Technical Service Bulletin: TSB110001

Alternator Change

This service parts topic announces a product change in Cummins-branded alternators. Delco Remy America (DRA), the supplier of the 21SI and 30SI Series alternators, has discontinued the production of these alternators. The 21SI will be replaced by the 22SI, and the 30SI will be replaced by the 33SI. This topic offers a comparison between the 21SI and 22SI and the 30SI and 33SI alternators.

Figure 1, 21SI Alternator

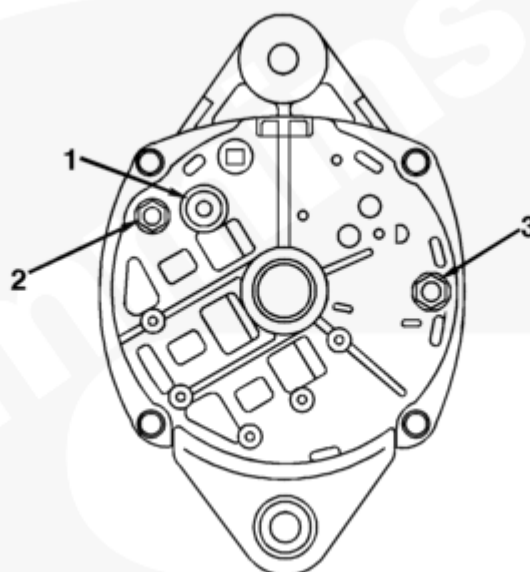
The ground terminal location of the 22SI alternator is 20 mm [0.79 in] lower and 11 mm [0.43 in] to the left of the 21SI ground terminal as viewed from the rear of the housing. (See Figs. 1 and 2.) The difference between the locations of the ground terminal on the two alternators is 23 mm [0.91 in].

The 22SI alternator is 5 mm [0.20 in] wider than the 21SI alternator. The maximum width of the 21SI alternator is 145 mm [5.71 in] compared to a width of 150 mm [5.91 in] for the 22SI.

Figure 3, 30SI Alternator

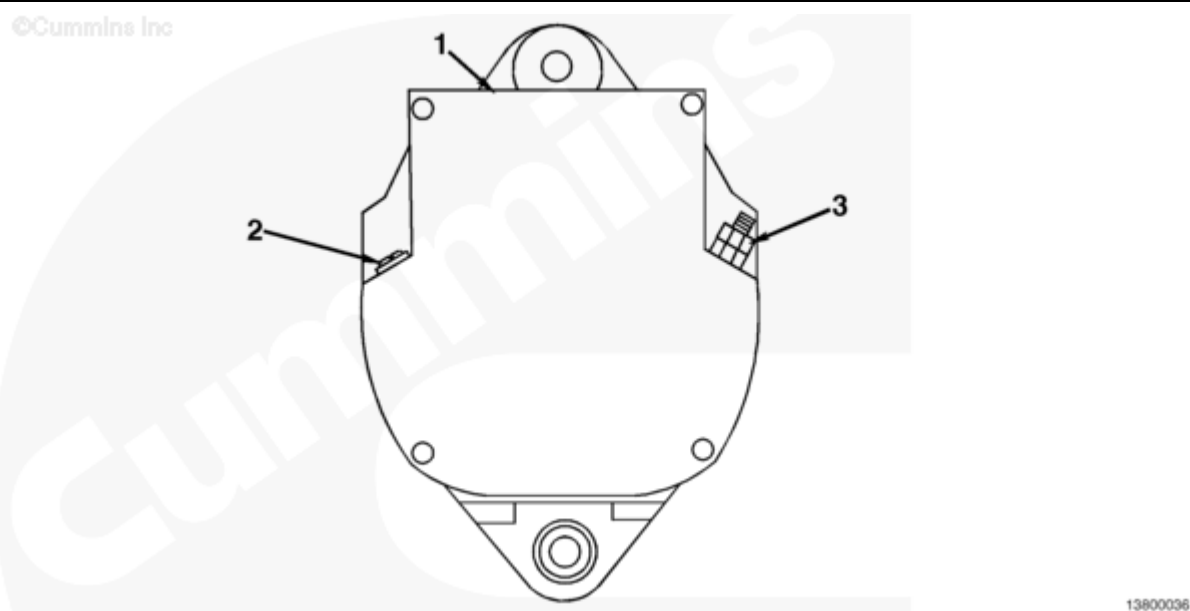
The ground terminal on both the 30SI and 33SI is located on top of the housing relative to the rear of the alternator.

The relay terminal location on the 30SI alternator is located on the left side when viewed from the rear of the housing. The relay terminal on the 33SI alternator is located in the upper left corner, next to the battery terminal, when viewed from the rear of the housing. The actual difference between the terminal locations is approximately 90 mm [3.54 in].

The battery terminal on the 30SI alternator is located on the right side when viewed from the rear of the housing. The battery terminal on the 33SI is located in the upper left corner of the alternator when viewed from the rear of the housing. The actual difference between the terminal locations is approximately 190 mm [7.48 in].

The 30SI alternator does **not** have an indicator terminal. The 33SI indicator terminal is located in the upper middle portion of the rear housing, next to the relay terminal.
